Docket Nos. 50-280
and 50-281

The Commission has issued the enclosed Amendment No.104 to Facility Operating License No. DPR-32 and Amendment No.104 to Facility Operating License No. DPR-37 for the Surry Power Station, Unit Nos. 1 and 2, respectively. The amendments consist of changes to the Technical Specifications in response to your applications transmitted by letter dated March 16, 1982, as supplemented June 28, August 3, and August 9, 1982, June 30, and October 27, 1983, March 22, and November 2, 1984, and April 17, and August 30, 1985; and by letter dated November 30, 1984, as supplemented April 12 and August 30, 1985.

These amendments revise the Technical Specifications to reflect changes to the VEPCO offsite and the Surry Power Station organizations, and revise the immediate notification requirements and the Licensee Event Reporting System to be consistent with Sections 50.72 and 50.73 of 10 CFR Part 50.

AMENDMENT TO FACILITY OPERATING LICENSE

1. The off-site organization for facility management and technical support shall be as shown on TS Figure 6.1-1.

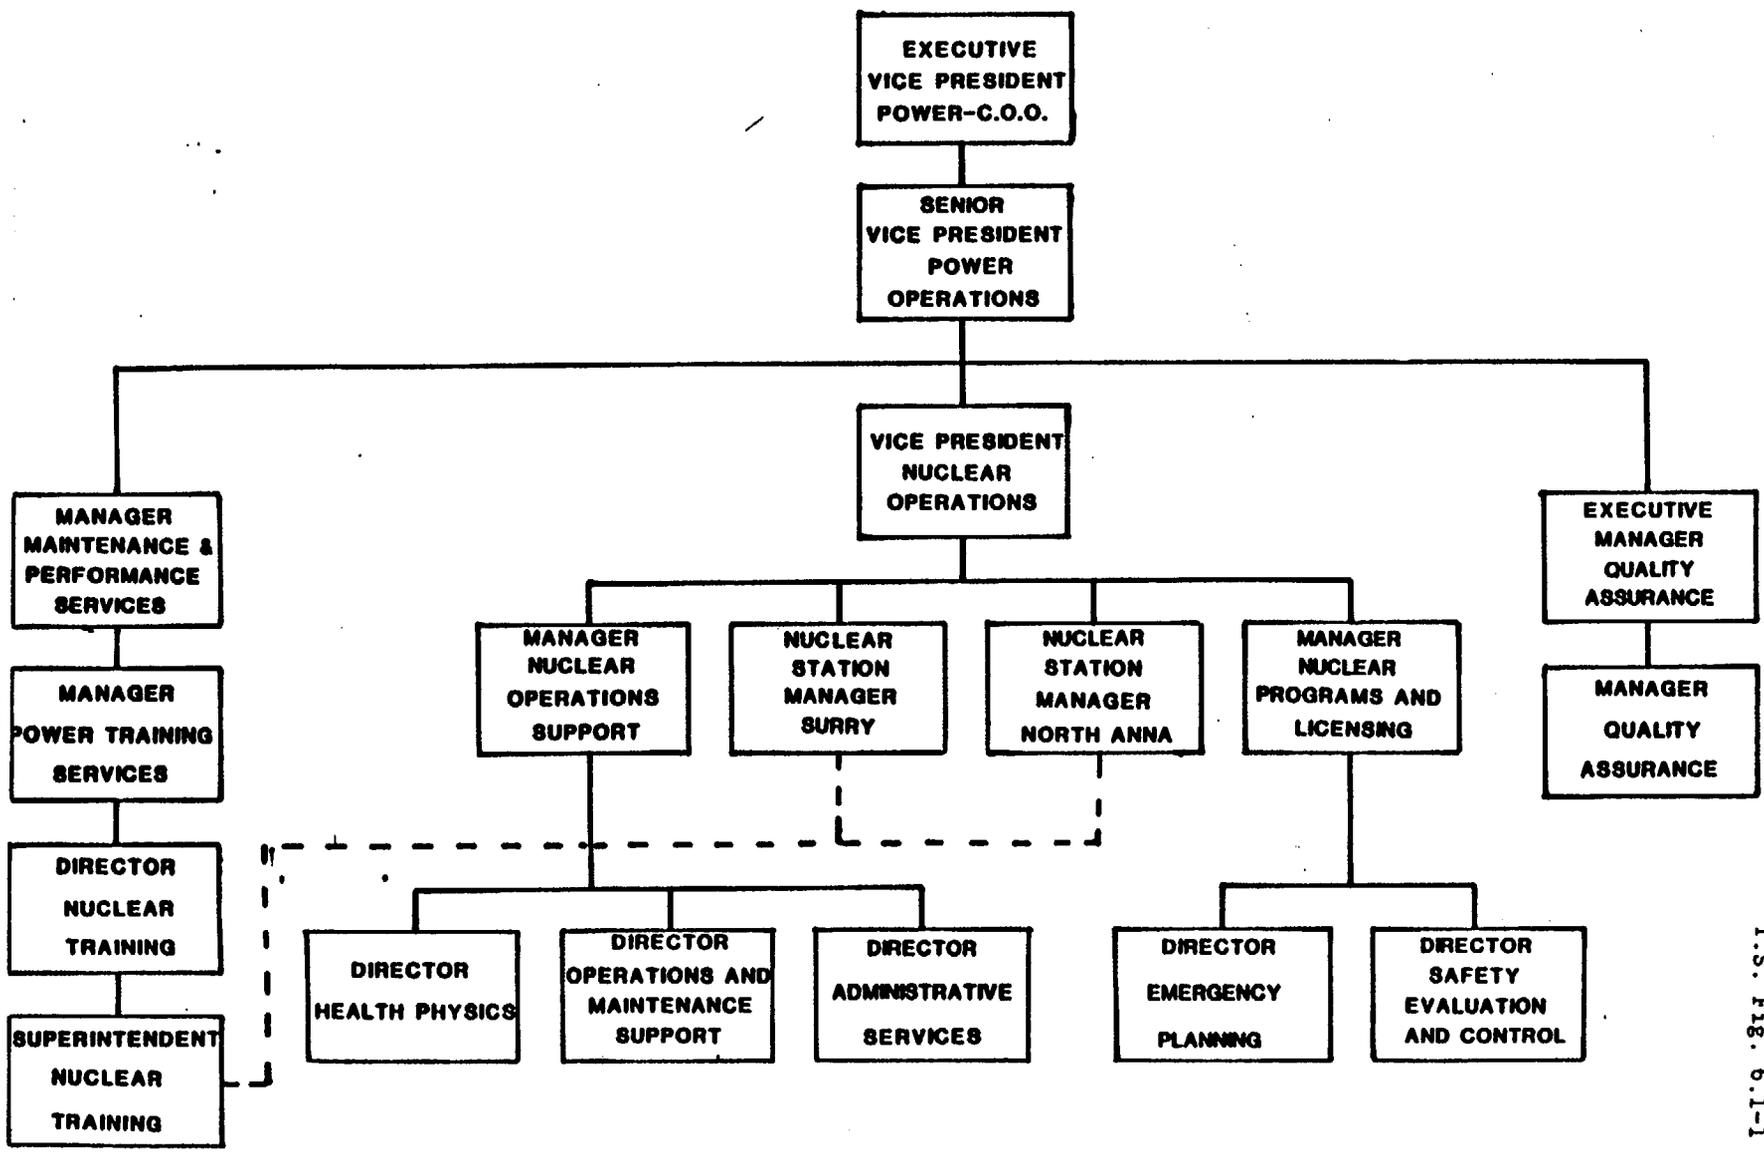
A reorganization within the Quality Assurance Department will result in the Manager, Quality Assurance at the station reporting directly to the Executive Manager, Quality Assurance. The position of Director-Emergency Planning will be created within the Nuclear Operations Department. The changes will be to enhance the quality assurance and emergency preparedness programs of the company.

We have reviewed the proposed changes and find them acceptable as they meet the acceptance criteria of Sections 13.1.1, 13.1.2, and 13.4 of NUREG-0800, the Standard Review Plan. Technical Specification Figures 6.1-1 and 6.1-2, as revised, show the reorganized offsite and onsite management organizations.

SURRY POWER STATION ORGANIZATION CHART

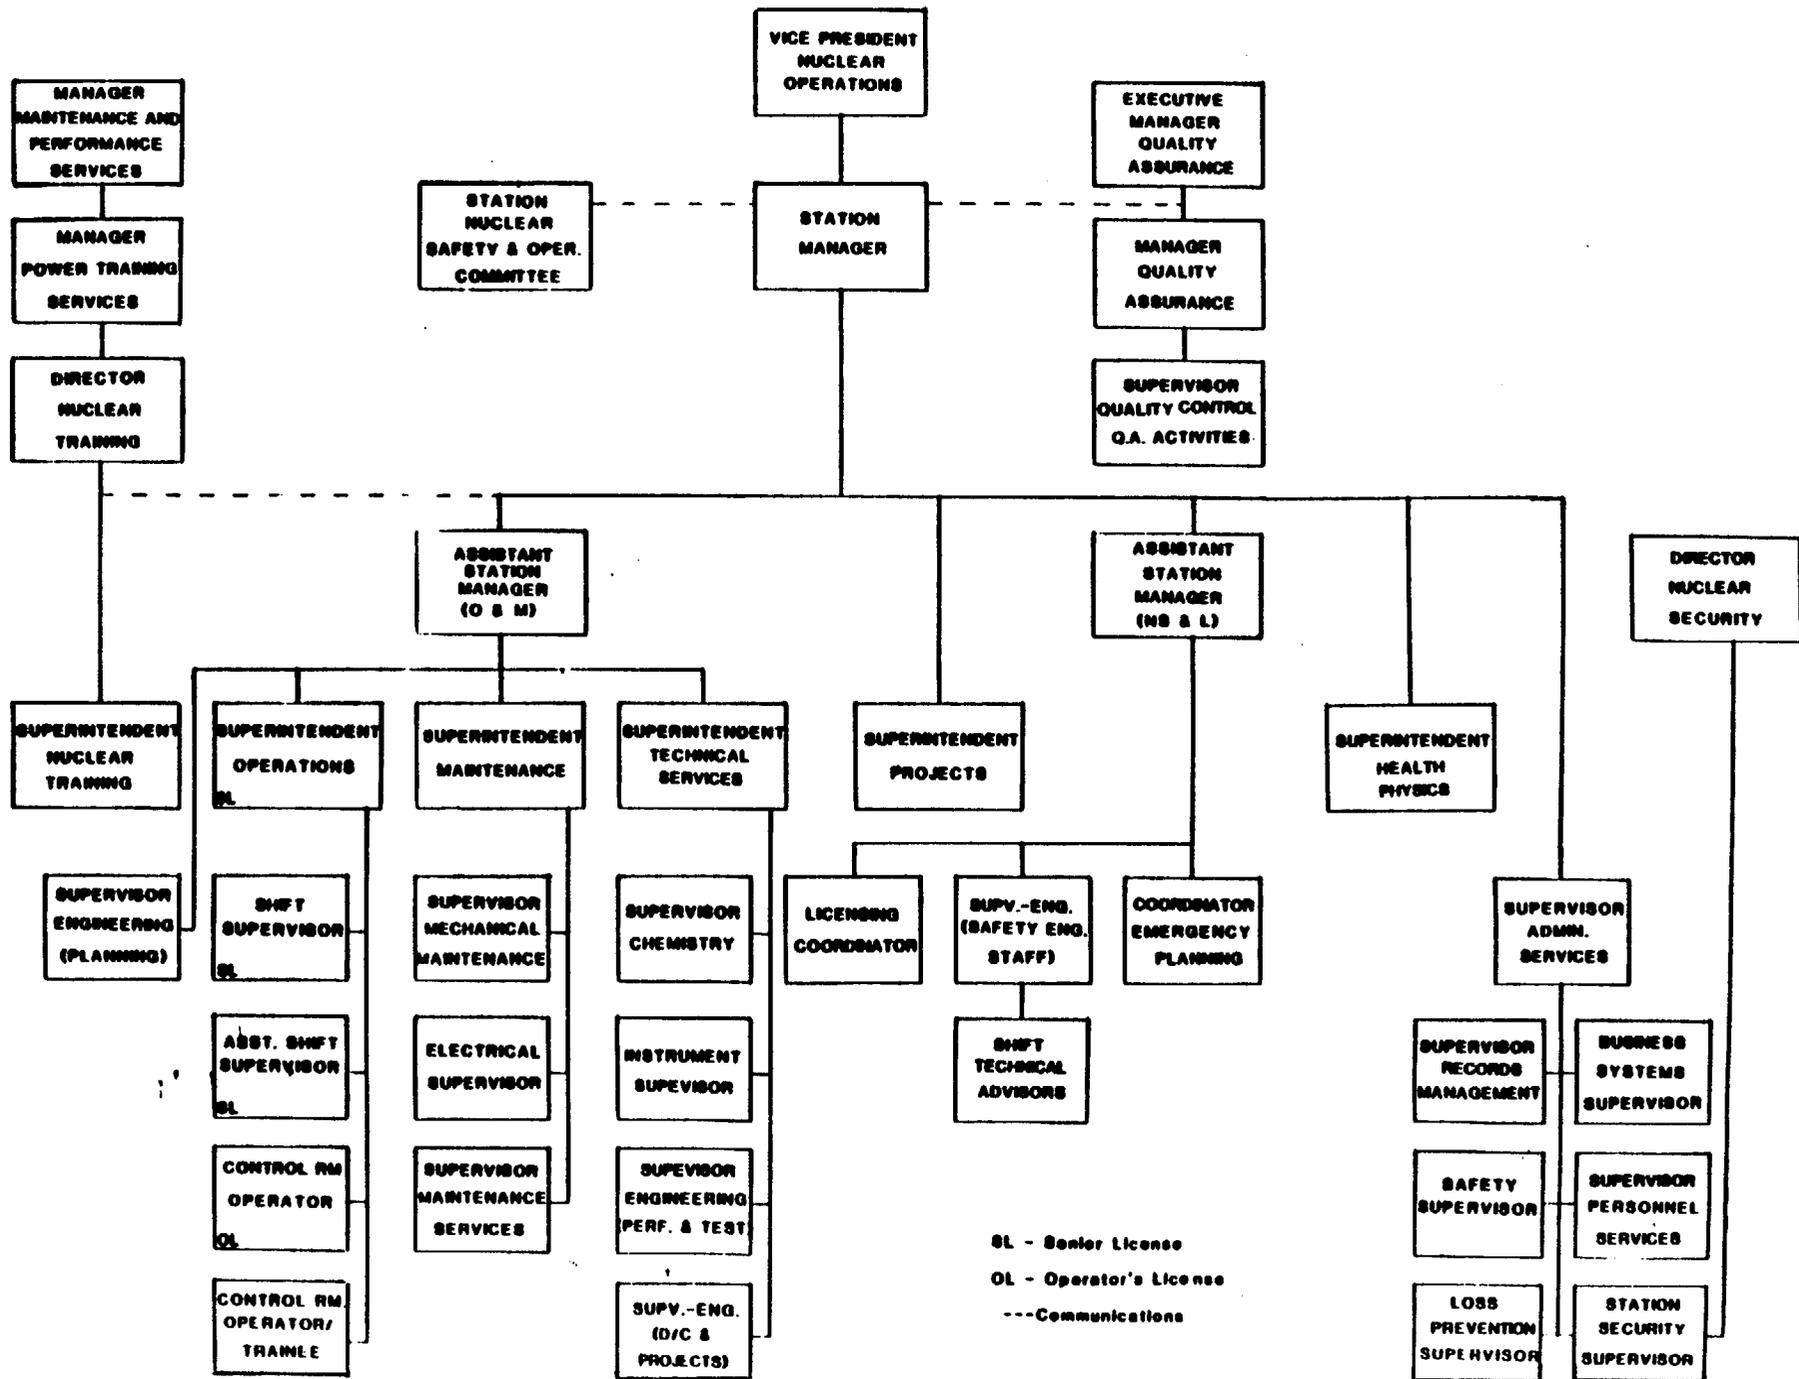
8. Proposed Administrative Change in Onsite Organization (1985)
